Response to Technical Review Comments

Clear River Energy Center and Burrillville Interconnection Project

**Re: Clear River Energy Center, LLC
Burrillville RI
Application No. 17-0079**

Technical Review Comments of Documents Received by RI DEM on April 4, 2017

- Legend**
- Limit of Disturbance
 - Project Impact Area
 - 200' Buffer Around Project Impact Area
 - Abutter's Parcel (BIP)
 - Abutter's Parcel (CREC)
 - Field Delineated Wetland
 - 50' Perimeter Wetland
 - 100' Riverbank Wetland
 - 200' Riverbank Buffer
 - Special Aquatic Site

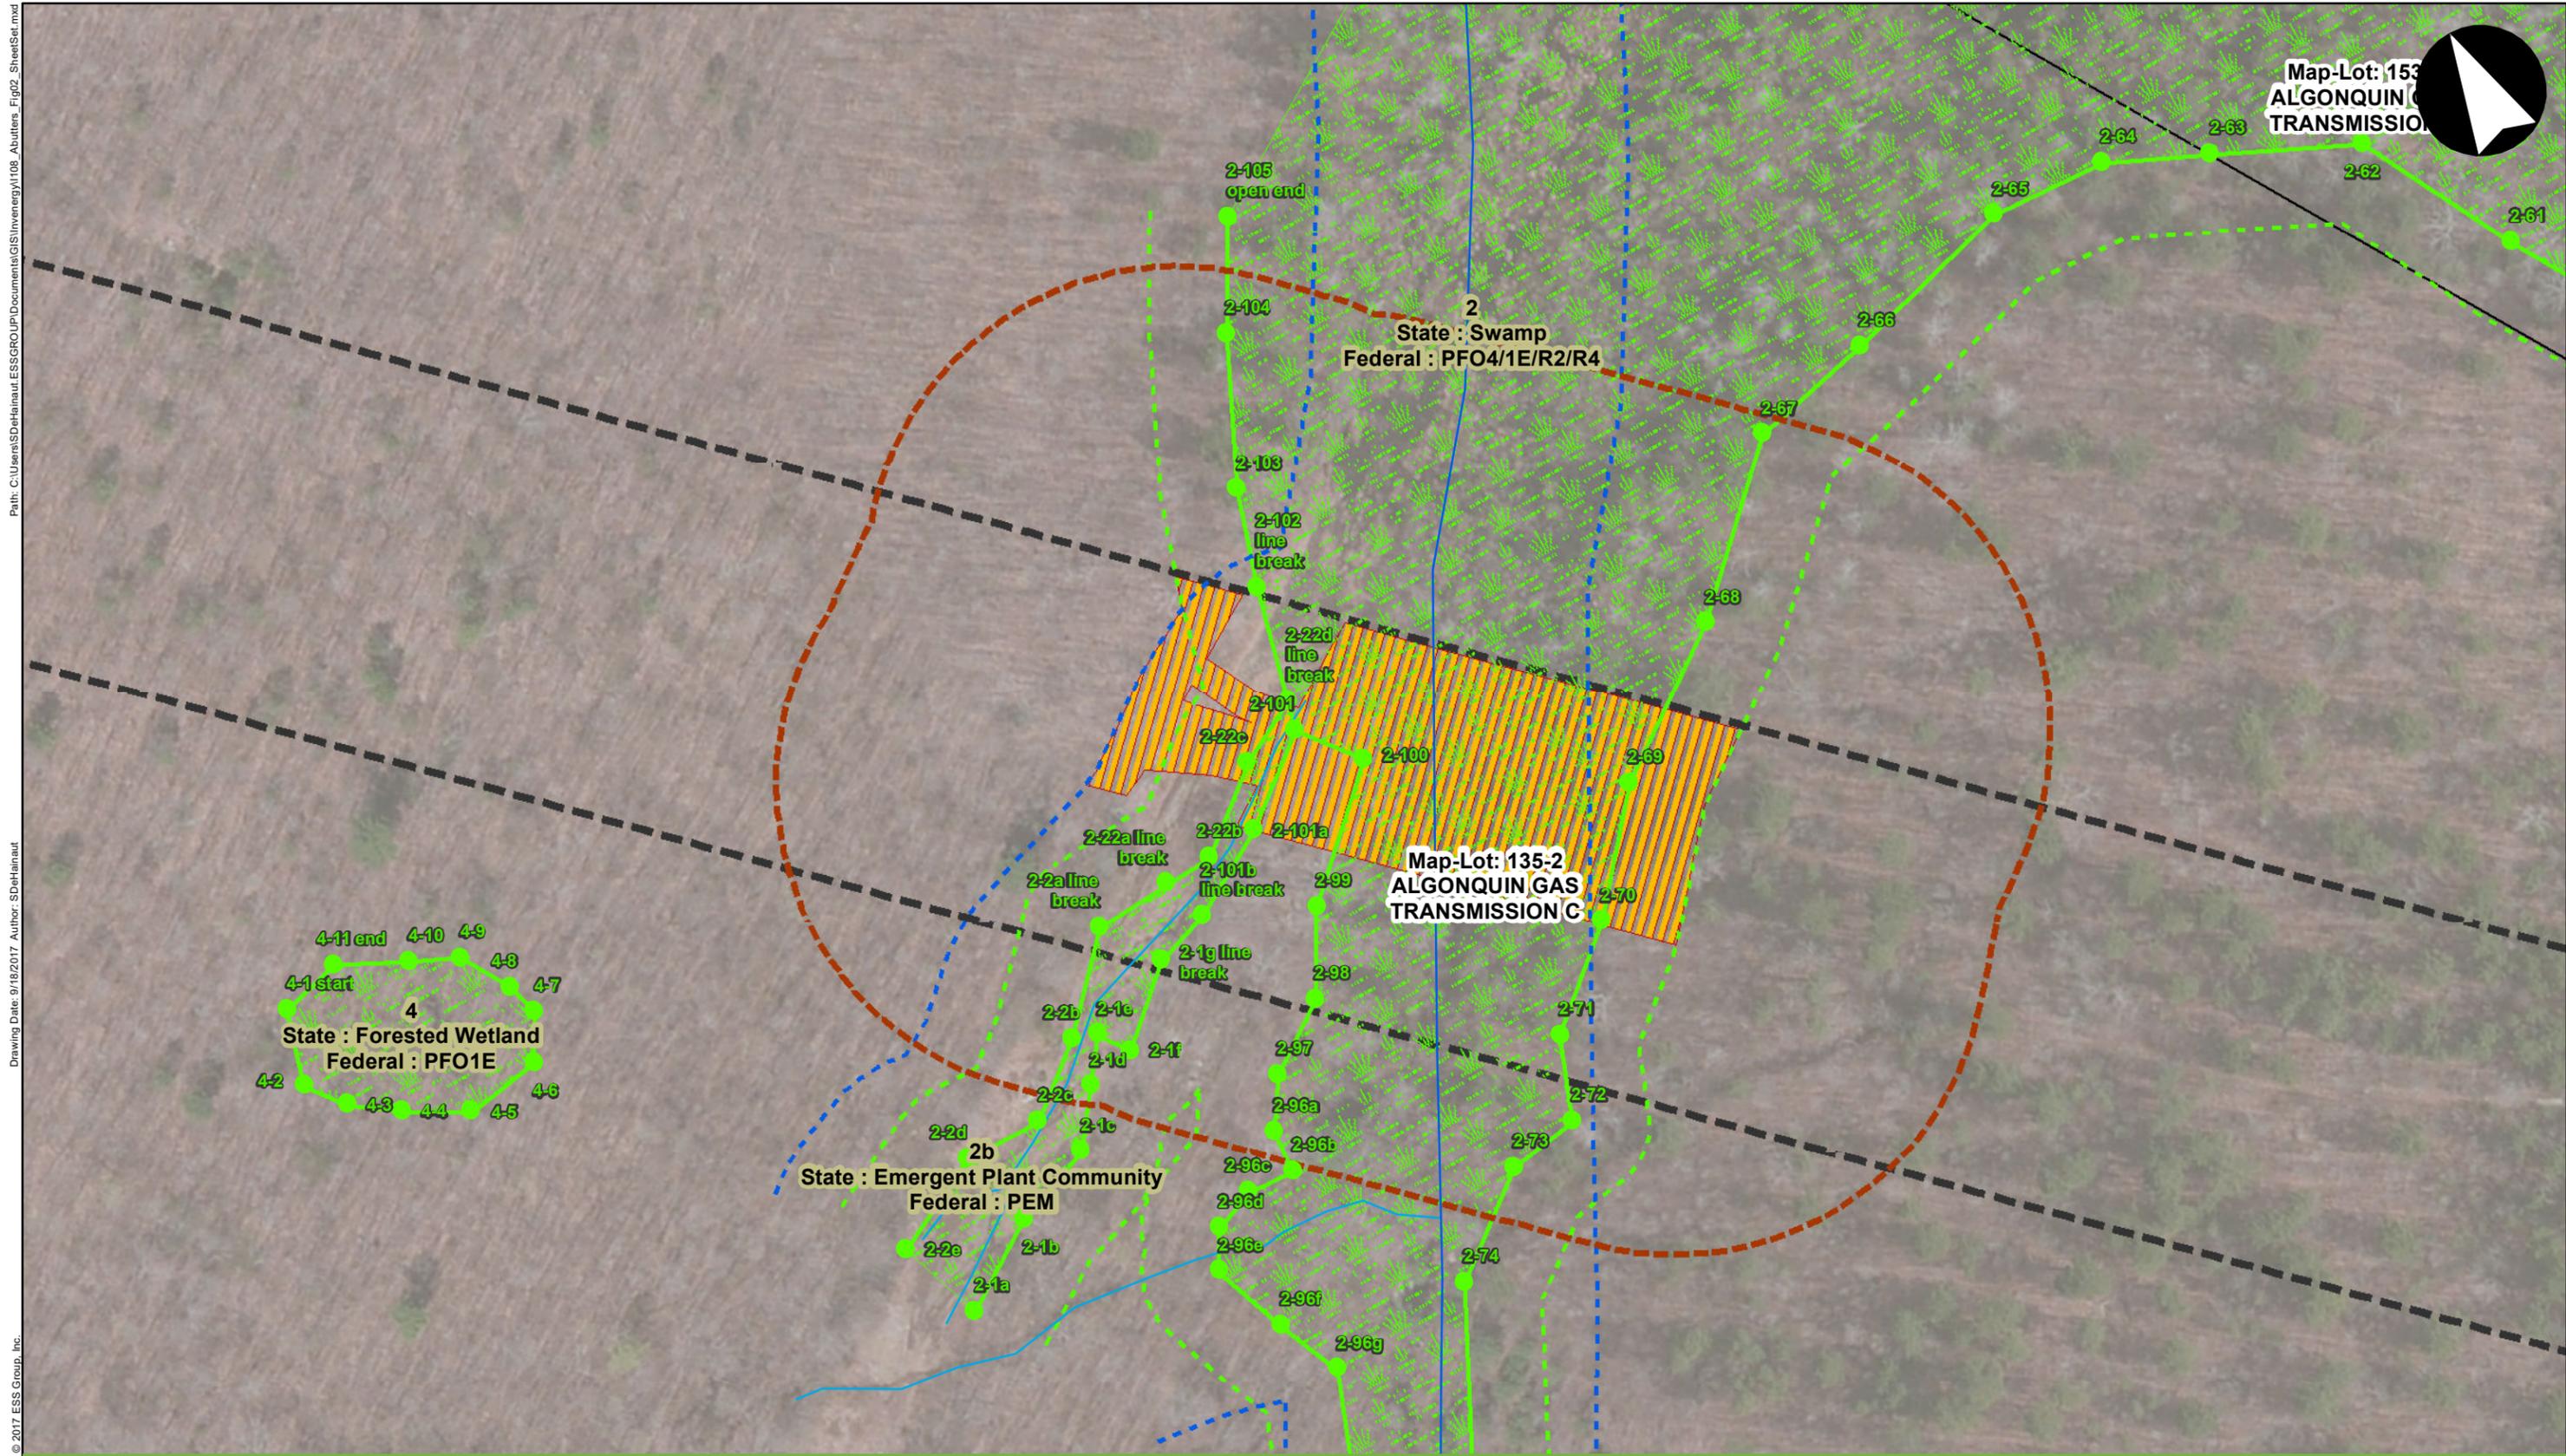
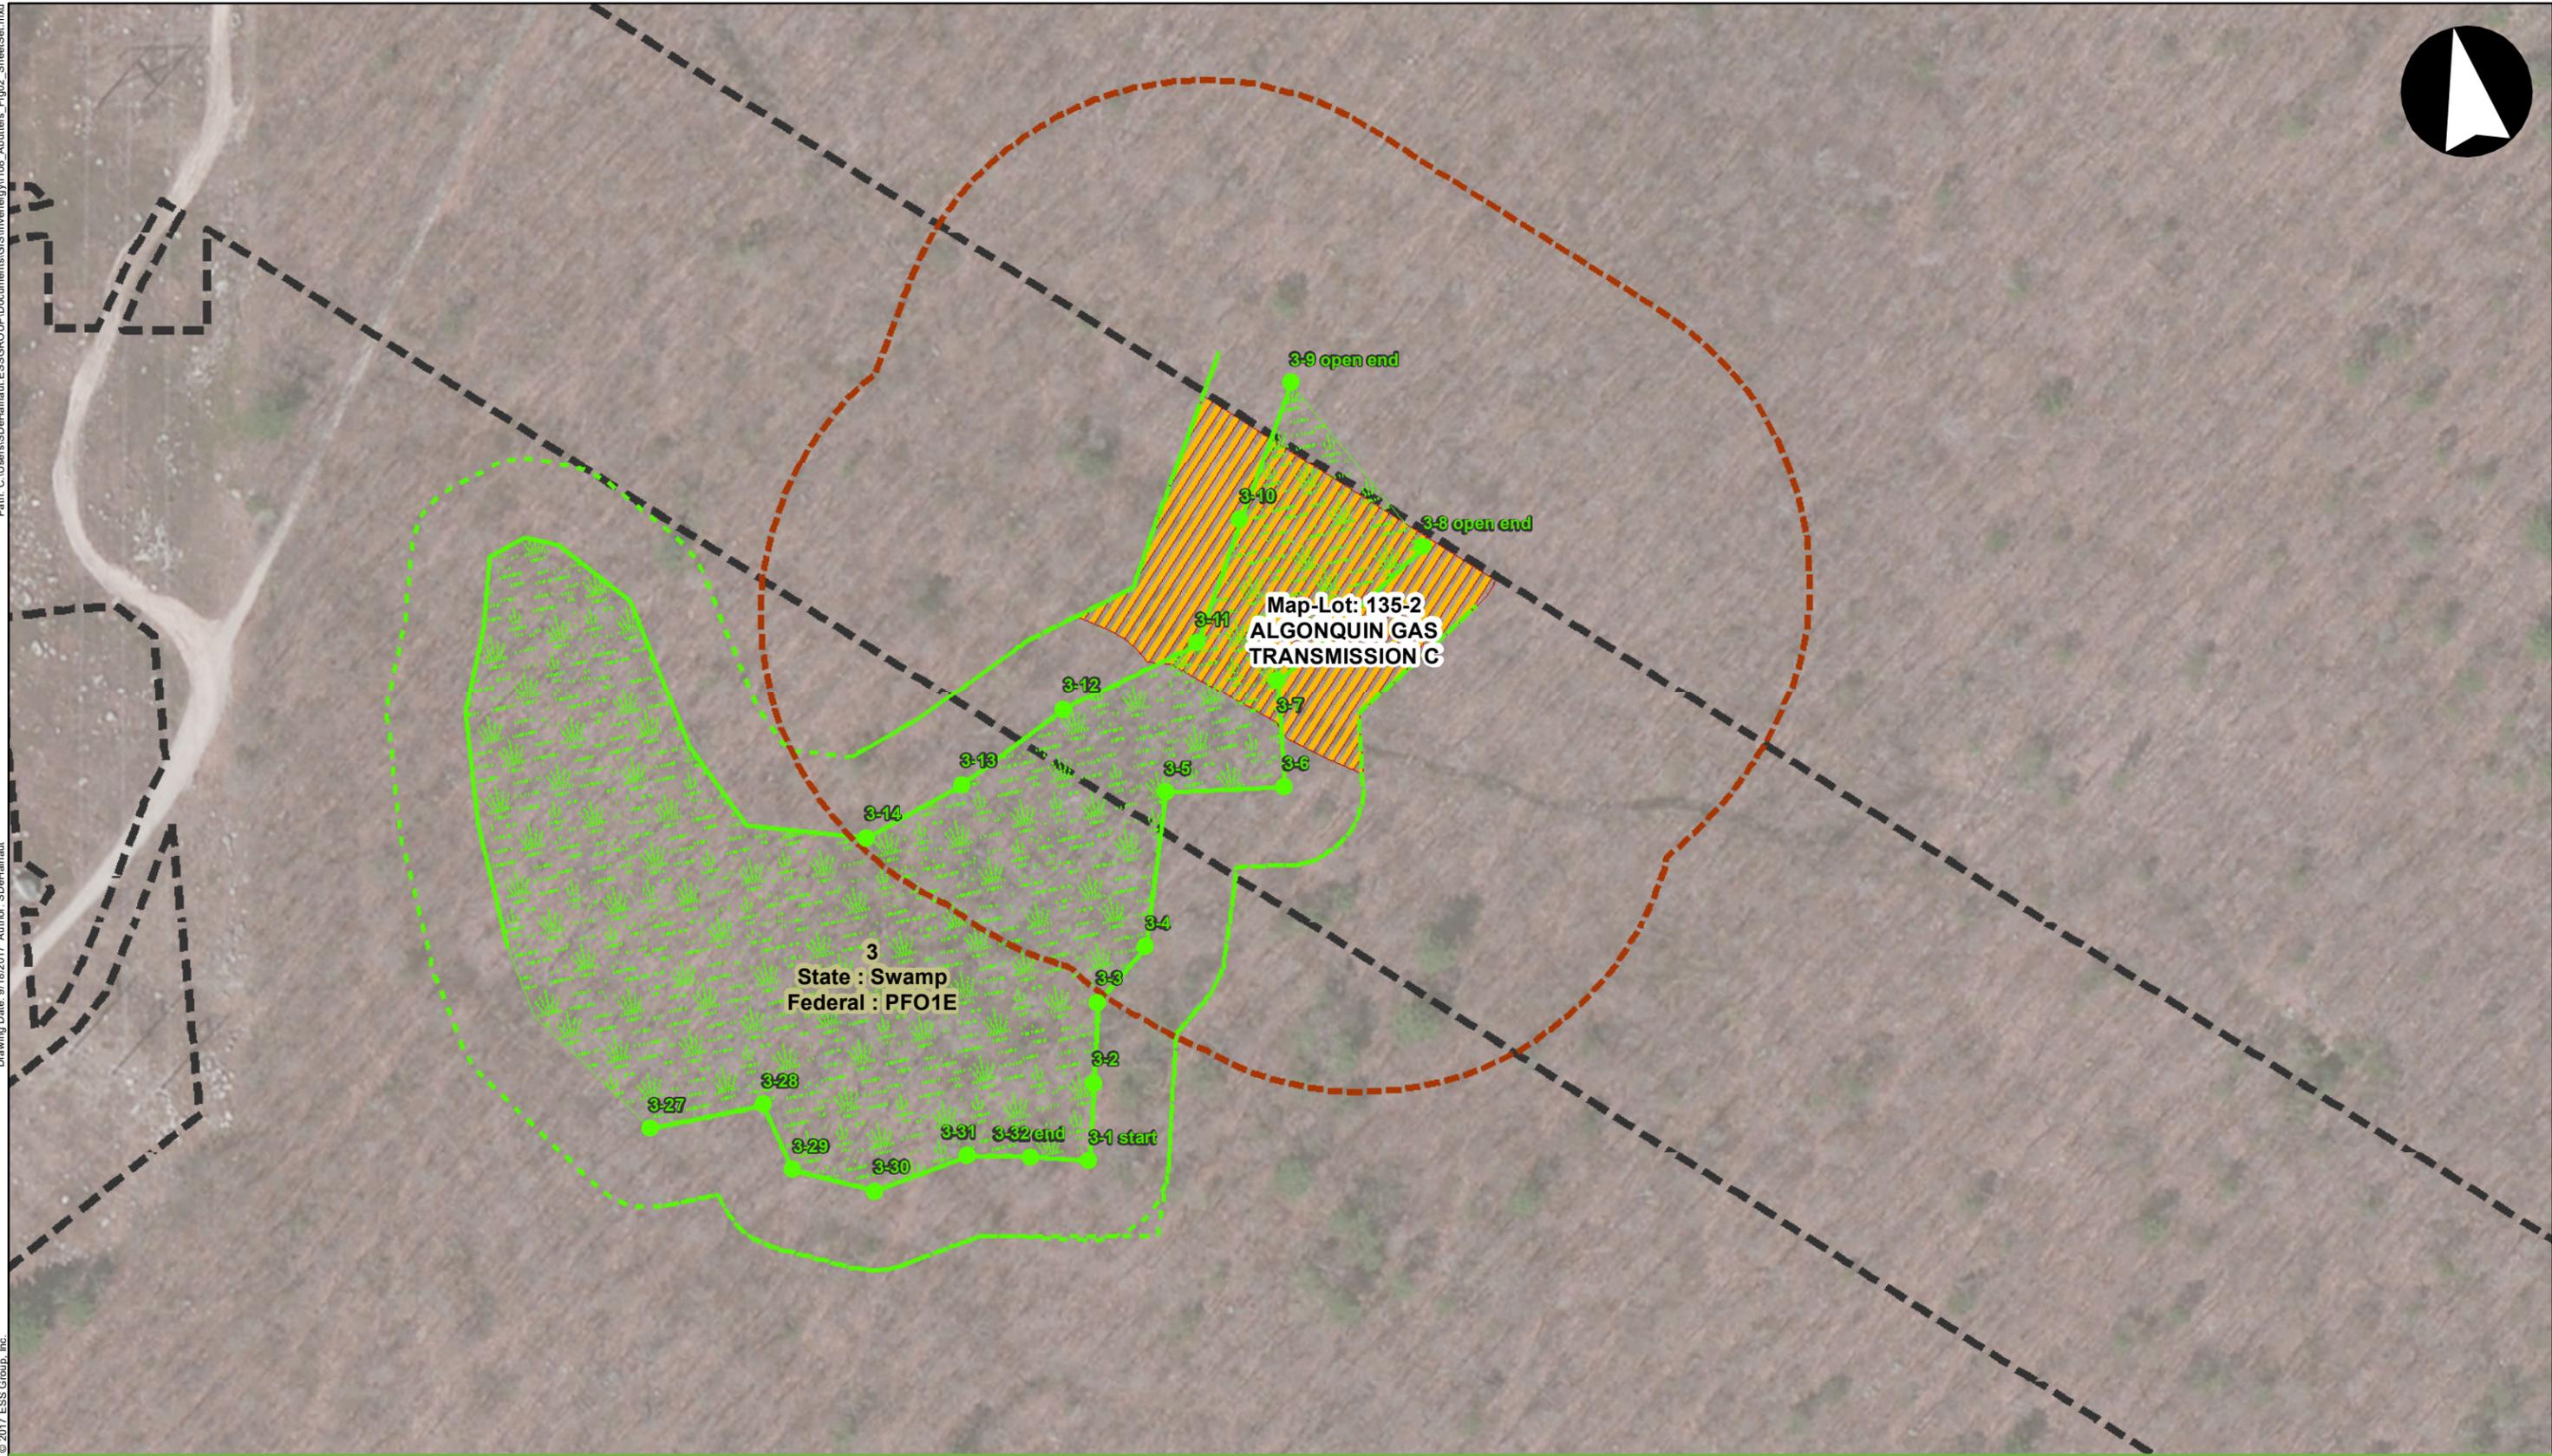
12. The Abutters Maps show project impact area, but the wetland is not identified on the various sheets. There is therefore no way to confirm if the maps are correct. Please clearly depict all wetland limits on the 200-foot radius maps and identify the wetlands similarly to how they are identified on the plan set.

Response: The abutters maps have been revised to depict all wetlands, and depicted wetlands have been labelled in a similar manner to the plan set (see Exhibit 2).
